February 4, 2008

MEMORANDUM

Subject: **Staff Analysis of Skyline 1 Corporation (Skycliff Planned Development)
Wastewater Reuse Permit, LA-000209-01 (Municipal Wastewater)**

Figure 1: Nitrate Concentration at the Brian Water Corporation Community Well

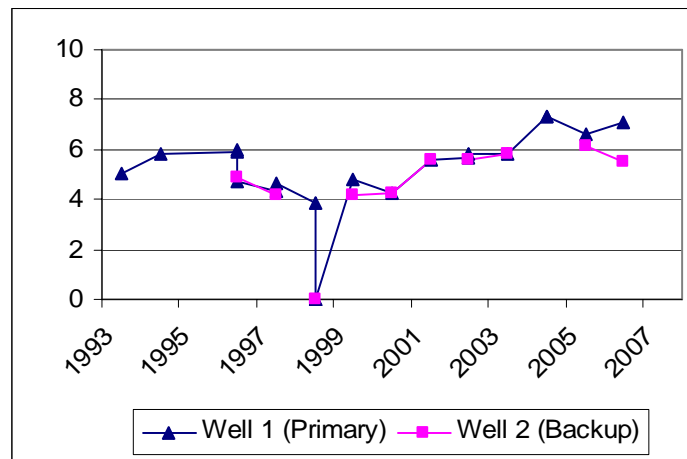
The NP Evaluation mass balance around the Brian Well aquifer resulted in an average nitrate concentration of 7.2 mg/L in groundwater, a rise of 0.6 mg/L. In general, an increase of less than 1 mg/L nitrate in the aquifer at the property boundary is considered an acceptable impact.

The results of annual nitrate sampling from the primary and backup Brian Water Corporation community wells are shown in the following plot. The drinking water Maximum Contaminant Level (MCL) for nitrate is 10 mg/L, which is the maximum permissible level of nitrate in water delivered to any user of a public water system.

Under the conservative approach taken by STRATA, Inc. in analyzing the risk to the Brian Well, 0.6 mg/L nitrate concentration increase is compliant with DEQ's reuse impact rules. **Therefore, it is not recommended that the permittee be required to conduct additional monitoring of the Brian Water Corporation community well at this time.** In the permit renewal process, which is addressed in Compliance Agreement CA-209-07 of the draft permit, it is required that the hydrogeologic analysis be revisited in light of all data collected at the site to assess the accuracy of the analysis and any affect the site has had on groundwater. This includes the drinking water contaminant sample data collected annually from the Brian Well in accordance to the DEQ community drinking water well sample program.

Figure 3: Close-up of Reuse Area at Skycliff

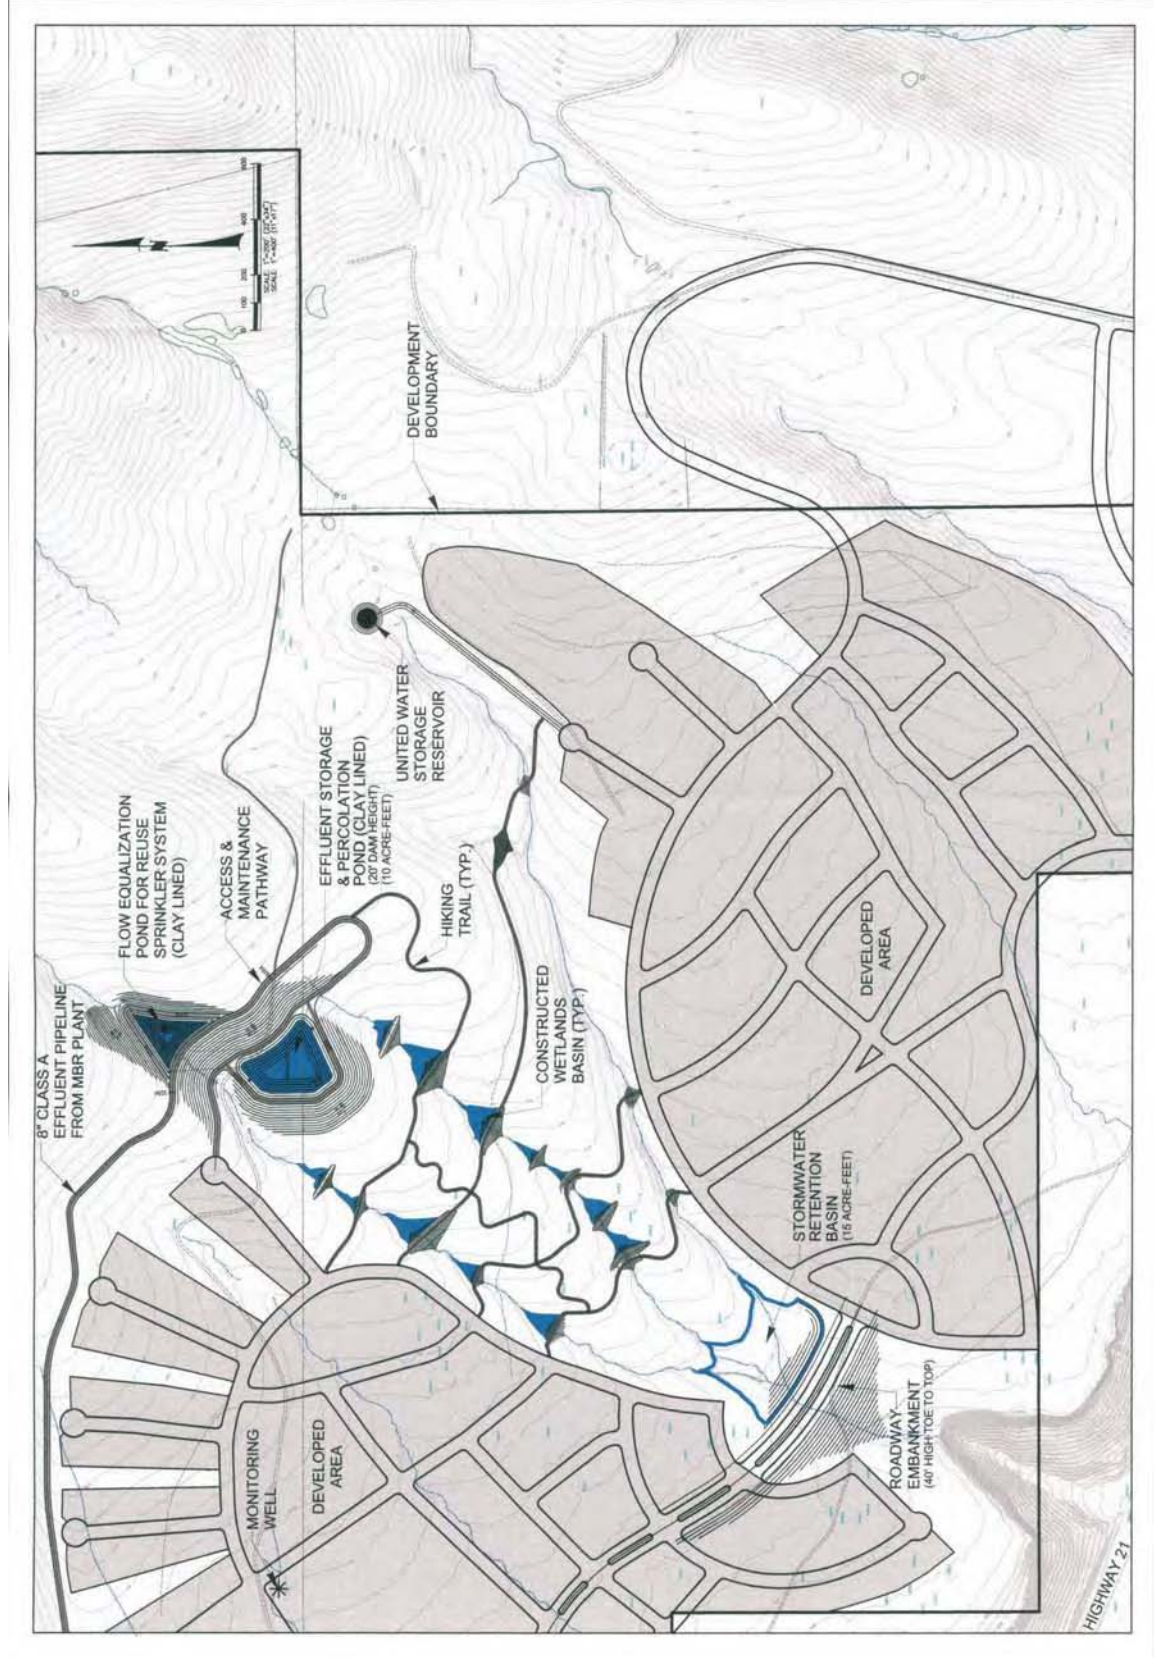
Infiltration values used in the water balance design for the riparian area are based on the Recommended Design Infiltration Rates, supplied by STRATA, Inc., in the above table. The infiltration value used for the riparian area is 0.3 in/hr, or 7.2 in/day, based on the upper recommended infiltration value for the secondary pond, which is nearest to the future location of the wetland area. Because the wetland ponds and channels will be constructed over time, the sizes and locations of the ponds will be determined based on the infiltration rates observed. See Figure 3 attached to this document for the pond and riparian area plan.

Figure 4: Well Boring and Geologic Cross-Section Locator Map at Skycliff

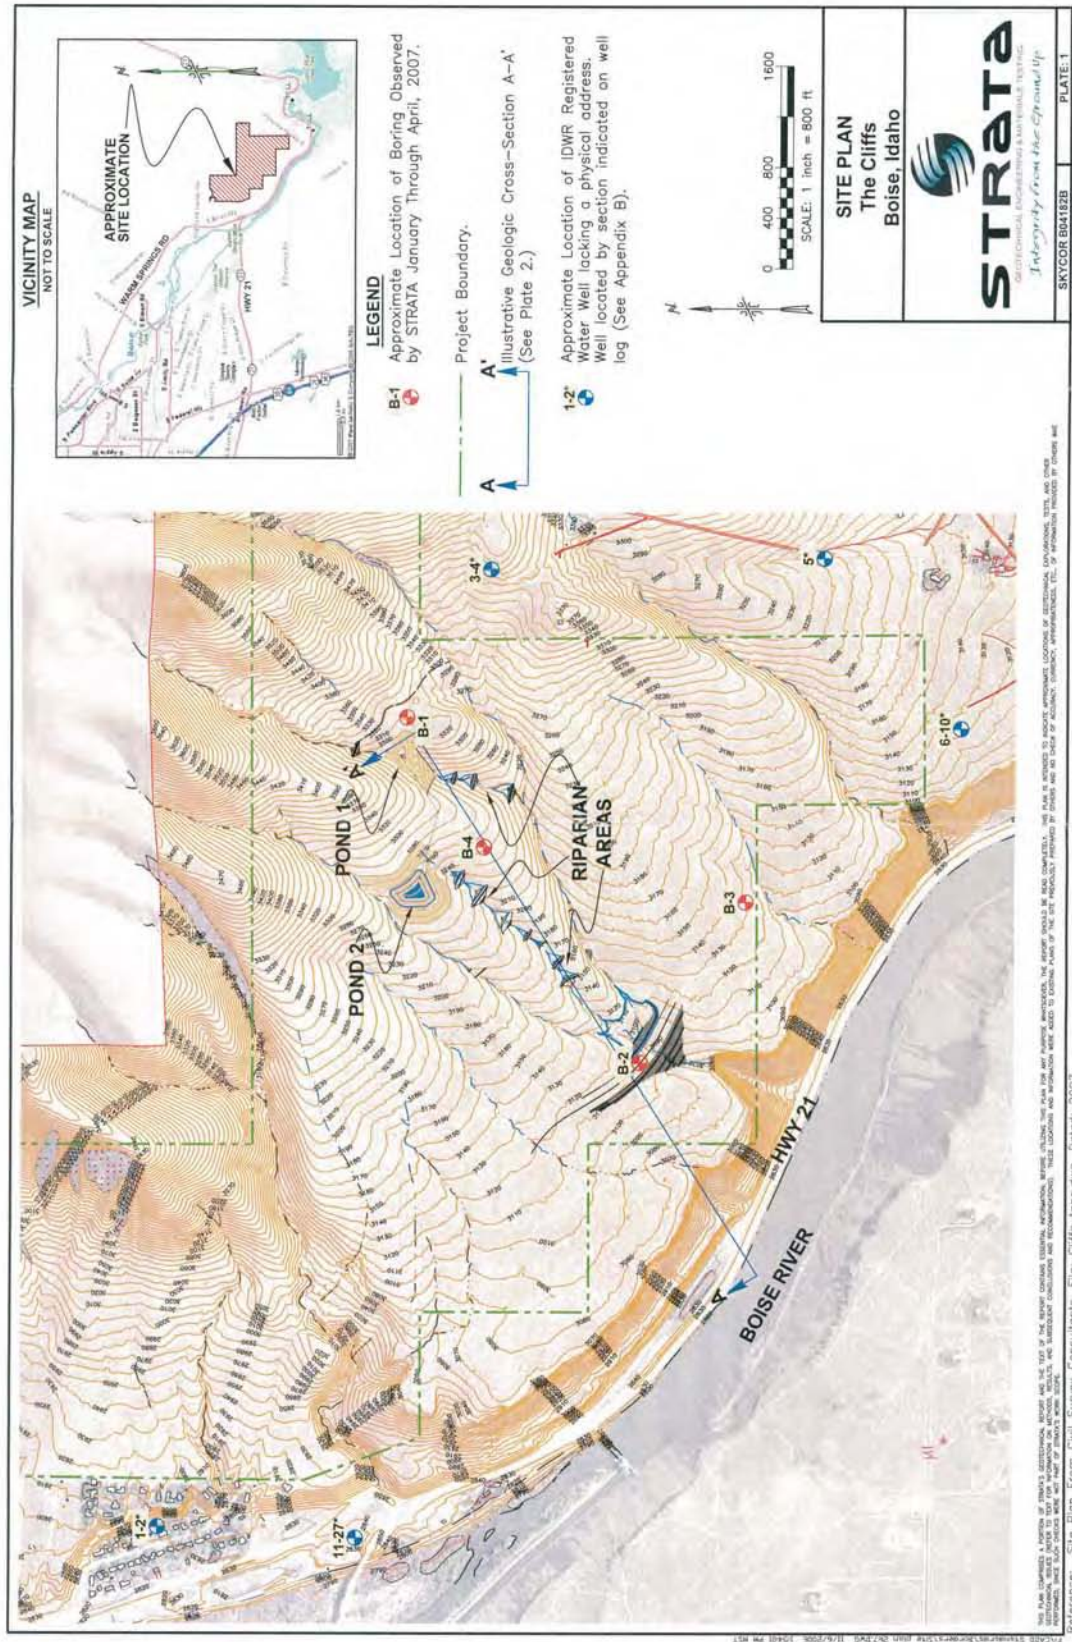
If effluent does not infiltrate through the confining layer and mix with ground water, there is a concern that the effluent could daylight between the site and Highway 21. In the NP Evaluation, STRATA, Inc. concludes that based on the visible geology, effluent will not daylight adjacent to Highway 21. However, **DEQ recommends that the permittee report any nuisance water or daylighting event at any point along the cliffs between the site and Highway 21 or Warm Springs Road.** Events are required to be reported orally immediately when they are discovered, and an investigation of what caused the nuisance water or daylighting event and any necessary corrective actions should be included in a follow-up letter to DEQ. **In addition, DEQ recommends that the permittee keep a log of all nuisance water complaints by residents of flooded basements or crawlspaces, or wet yards, and any follow-up actions taken.** This log is recommended in the Draft Permit to be submitted each year with the Annual Report.

The scenario of effluent mixing directly with the Boise River with no prior mixing is considered possible in the subsurface geology cross section shown in Figure 4 attached to this document. If recharge water were to travel in the vadose, or unsaturated, zone labeled as QTg/Qag in Figure 4, it could potentially mix directly with the water of the Boise River. STRATA, Inc. conducted a Nutrient-Pathogen (NP) analysis, dated May 18, 2007 with an addendum dated August 1, 2007, which analyzed the impact of nitrate and phosphorus in effluent on the Boise River. In this analysis, all effluent was assumed to enter the Boise River with no previous mixing. The Boise River flow was considered to be 181 cfs, which is the 10-year low as measured at the Glenwood Bridge. The evaluation stated that the Boise River has a low mean flow value of 332 cfs, and an annual mean value of 1,270 cfs, so analysis using 181 cfs is considered conservative. The background concentrations used for the Boise River were 0.02 mg/L phosphate and 0.04 mg/L nitrate as measured on September 21, 2004 by the USGS at the diversion dam near the site.

Due to the theoretical nature of the hydrogeological evaluation, **DEQ recommends that a monitoring well be drilled near the recharge basins** in an effort to provide actual information on the affect that the development has on the subsurface. The monitoring well location has been planned in a location SW of the recharge basin, placing it between the recharge basins and both the Boise River and the Brian Water Corporation Well. It is planned to drill the well to the basalt of Gowen Terrace, with the actual termination to be determined during drilling. In following sections, monitoring and subsequent analysis of the data collected from this monitoring well is discussed.
